### **Urgent Field Safety Notice** *SBN-CPS-2017-003*

# cobas<sup>®</sup> 8100 BRF and URF with Software Version 02-xx: Buffering May Cause Specimen Spillage

Product Name	cobas® 8100 automated workflow series
Product Description	BRF for cobas® 8100 URF for cobas® 8100
GMMI / Part No Device Identifier	BRF for cobas 8100 GMMI 07439954001 URF for cobas 8100 GMMI 07441657001
Production Identifier (Lot No./Serial No.)	Not applicable
SW Version	Software version 02-xx
Type of Action	Field Safety Corrective Action (FSCA)

(Fig 1: English version of screen)

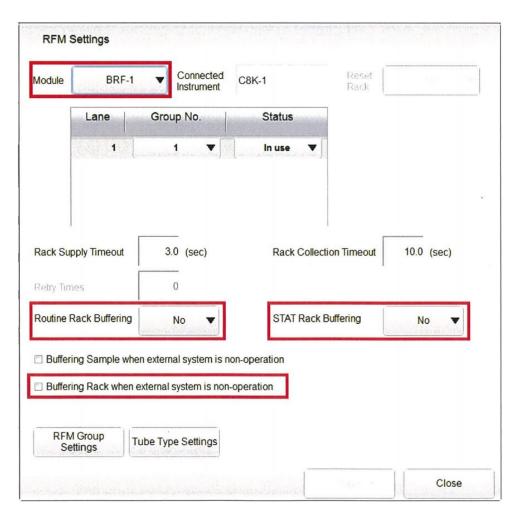
To prevent this issue, rack buffering has to be deactivated until the software is upgraded to version 03-01 onwards. Please refer to the following procedure to disable rack buffering:

- · Open the RFM Setting Screen.
- · Choose BRF and URF from the pull-down menu for "Module".
- Set "Routine Rack Buffering" to "No".
- · Set "STAT Rack Buffering" to "No".
- Uncheck "Buffering Rack when external system is in non-operation".
- Press "Save" button.
- · Repeat steps 2 to 6 for all connected BRF and URF modules.
- Reboot the system.
